R66 SERVICE BULLETIN SB-05B
(supersedes R66 SB-05, R66 SB-05A, and R66 SL-03A)

DATE: 03 December 2012 **REV B:** 21 December 2012

SUBJECT: Clutch Retaining Bolt

ROTORCRAFT AFFECTED: R66 helicopters S/N 0003 thru 0271.

FIGURE 1

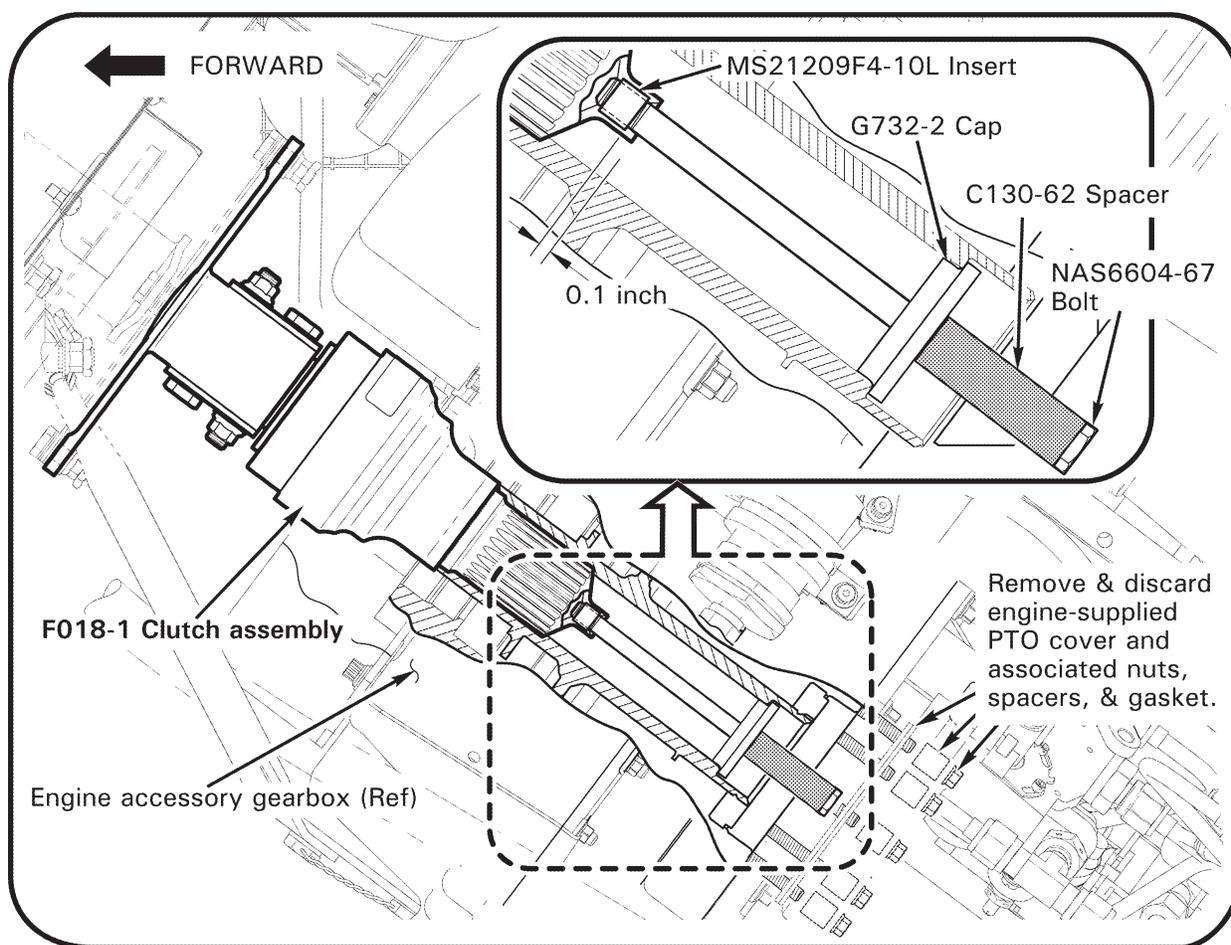
BACKGROUND: RHC has received additional reports of a broken bolt which retains the clutch assembly and eliminates play between the engine PTO (power take-off) shaft and clutch splines. This bulletin requires installing a new bolt and cap configuration and discarding the PTO cover. Some helicopters may also require replacement of the thread insert in the clutch housing.

1. Remove engine cowling per R66 Maintenance Manual (MM) § 53-21.
2. Refer to Figure 1. If installed, remove and discard engine-supplied PTO cover and associated nuts, spacers, and gasket.
3. Remove clutch retaining bolt, washer, G732-1 or G732-2 cap, and tube (if installed) and determine bolt length. A strap wrench or plastic-jaw pliers may be used to hold clutch assembly housing when removing bolt (avoid damaging identification plate). Discard bolt, washer, G732-1 cap, and tube; retain G732-2 cap.
4. If an NAS6604-57 bolt was removed, verify end of MS21209F4-10L thread insert is 0.1 inch below end of clutch housing; contact [RHC Technical Support](#) if thread insert position is incorrect.
5. Install C130-62 spacer and G732-2 cap on NAS6604-67 bolt and install bolt. Standard torque bolt to 132 in.-lb per MM § 20-32 and torque stripe.
6. Install engine cowling per MM § 53-21.
